Oyster Creek Generating Station
Facility Operating License No. DPR-16
NRC Docket No. 50219 50-219

Subject: Clarifications to Responses to NRC Request for Additional Information
related to Severe Accident Management Alternatives (SAMA) for
Oyster Creek Generating Station (TAC No. MC7625)

Clarifications Associated with SAMA RAI Responses

Figure 1c-1 Review Process for Oyster Creek PRA Model

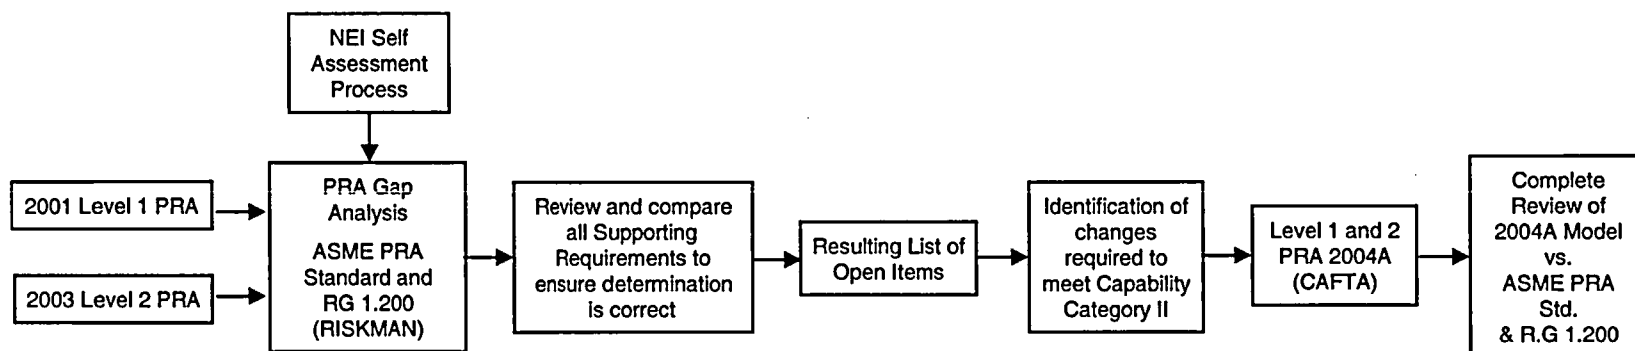
Was the 2004A analysis subjected to a complete self assessment or was the focus of the re-review limited to those gaps found in the 2001 PRA? Of concern is the completeness/applicability self-assessment of the 2001 PRA relative to the 2004A model considering the extensive changes from the 2001 model to the 2004 model not the least of which is the change from support state (RISKMAN) modeling to linked fault tree (CAFTA) modeling.

The Oyster Creek 2004A model, documentation, and results were subjected to a complete self assessment to ensure that they reflected the insights from the RISKMAN model and the model changes made during the 2004A model preparation.

AmerGen performed the analysis of the "gaps" of the 2001 Level 1 PRA and the 2003 Level 2 / LERF PRA relative to the ASME PRA Standard [1] and the RG 1.200 [2] changes by direct comparison between the Standards and the PRA. The NEI self-assessment process was used as a second check, but was not a primary input. It was used to ensure that no deficiencies that had previously been pointed out continued to persist. The assessment was performed on the model and documentation compared with the two documents, Ref. [1] and [2].

The 2004A model was targeted to comply with the ASME PRA Standard. The areas of compliance in the 2001 PRA model were retained and updated using a consistent methodology to meet Ref. [1] and [2].

Following development of the 2004A model, it was then completely re-assessed using the Ref. [1] and [2].

Figure 1c-1 summarizes this process.
